# 1953 - 1954 Corvette: Service News: Powerglide Clutch Interference

**Subject:** Powerglide Clutch

**Model and Year:** 1953 - 1954 Corvette

**Source:** Chevrolet Service News

*Fig. 2—Powerglide Valve Body Re-worked.*

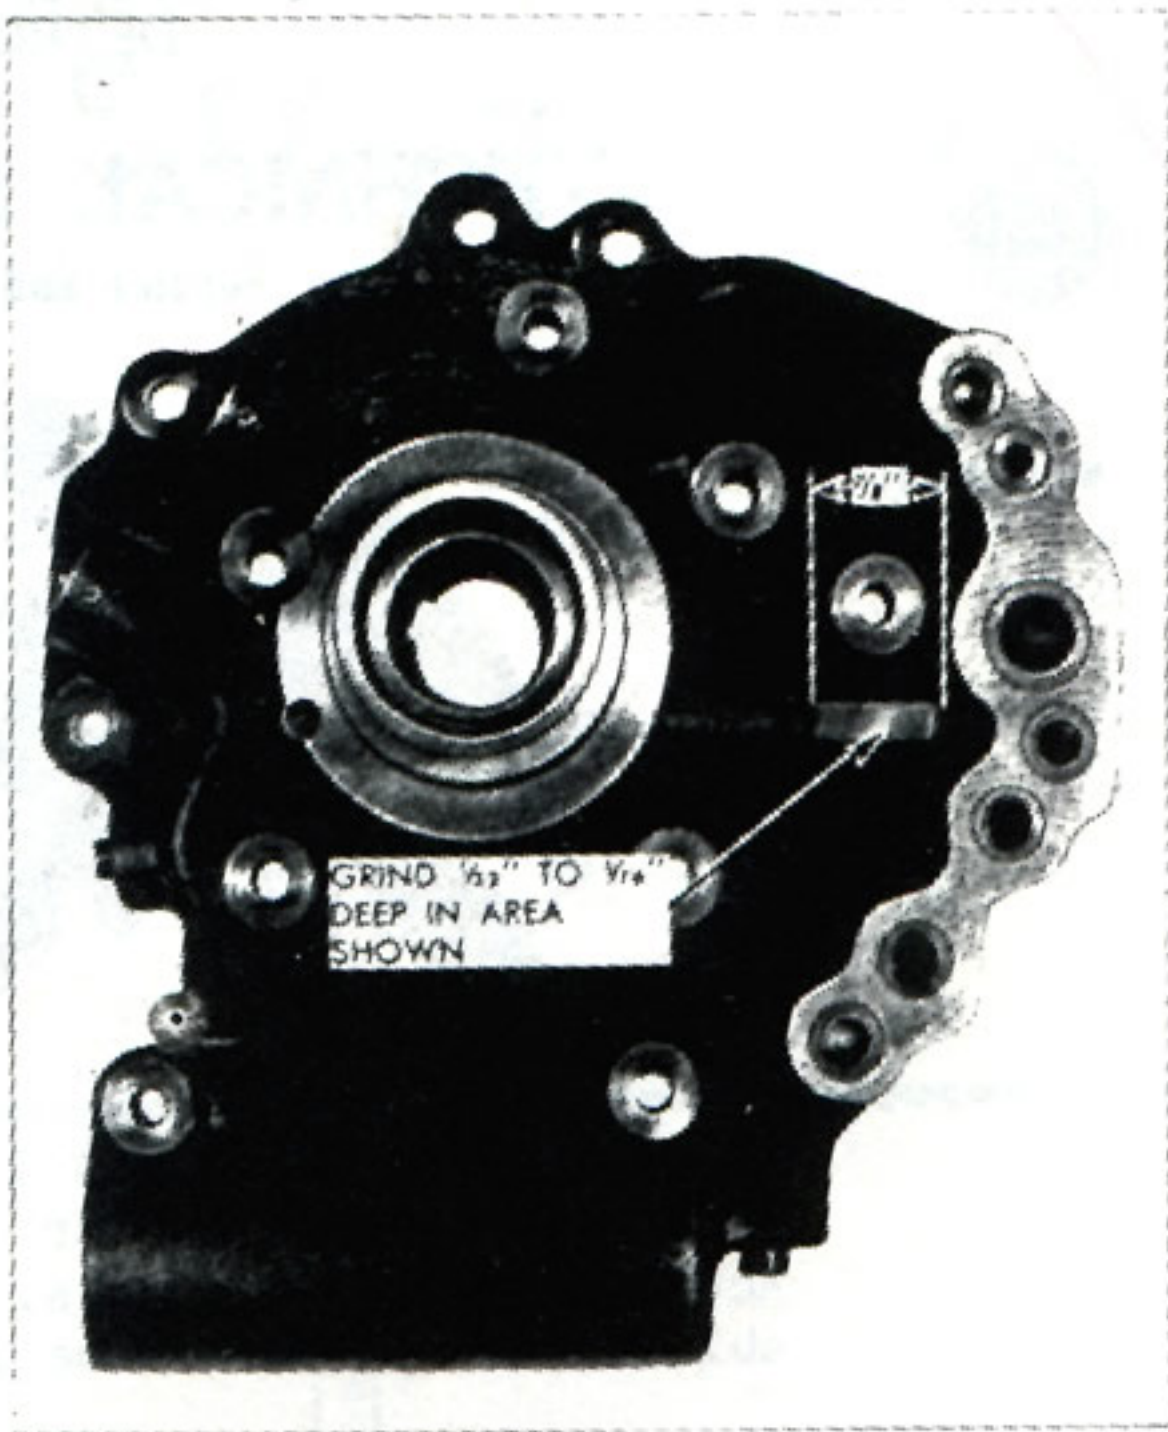
Due to limit stack conditions, a point of interference is possible when using a service replacement clutch drum or clutch assembly in 1953-54 Powerglide transmissions. The difficulty is caused by a ledge incorporated on the front face of a service replacement clutch drum, which can contact an embossed area on the valve body casting.

The interference can only be occasioned when using the following parts for replacement:

3740045 Clutch Drum Assembly

3742454 Clutch Assembly

3743840 Clutch Assembly

3748702 Clutch Assembly

Where clutch drum-valve body interference is noted when installing one of the above assemblies the valve body must be reworked to obtain drum operating clearance, as shown in Figure 2.
